UNITED STATES PATENT AND TRADEMARK OFFICE

APPLICATION NO.	FILING DATE	FIRST NAMED INVENTOR	ATTORNEY DOCKET NO.	CONFIRMATION NO.
10/767,211	01/28/2004	Frederick J. Dojan	005127.00275	2584

Office Action Summary	Application No.	Applicant(s)	
	10/767,211	DOJAN ET AL.	
	Examiner	Art Unit	
	Ted Kavanaugh	3728

DETAILED ACTION

FIG. 3

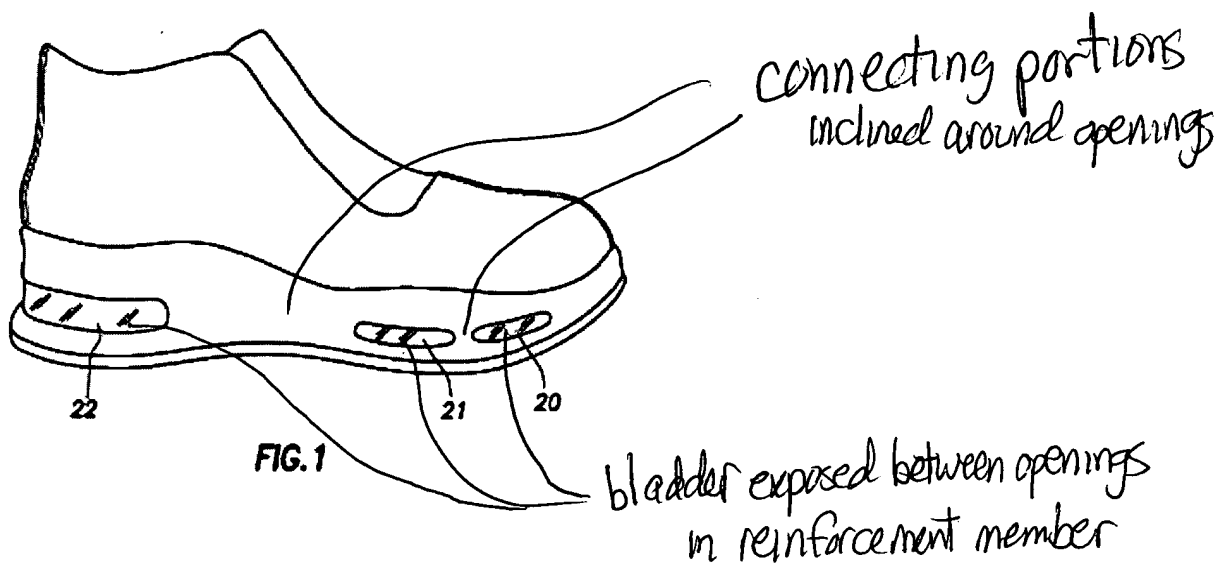
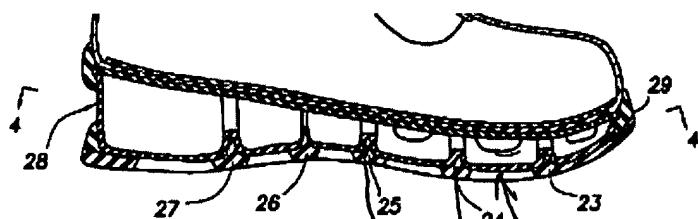
Pavone teaches an article of footwear comprising an upper and a sole structure as claimed; see the marked-up figures below. a sole component as claimed including a bladder and a reinforcing structure at least partially recessed into the barrier material as claimed. See the marked-up figures below. When the bladder is inflated (see col. 2, lines 60-67) to a desired pressure it will inherently place the connecting portions of the reinforcing structure in tension assuming the pressure is greater than atmospheric pressure.

1st surface
 reinforcing structure partially recessed in the 1st surface
 connecting portions recessed in sidewall

FIG. 4

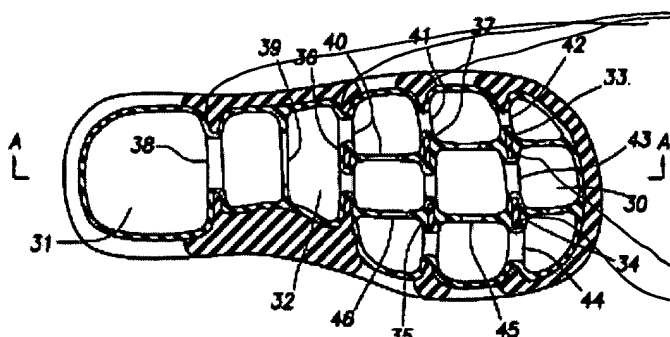
bladder

FIG. 5

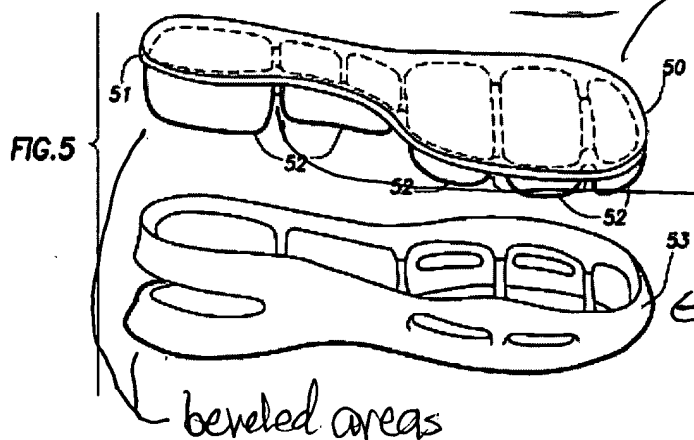
flexion indentations/Int. bonds

reinforcement member

beveled areas
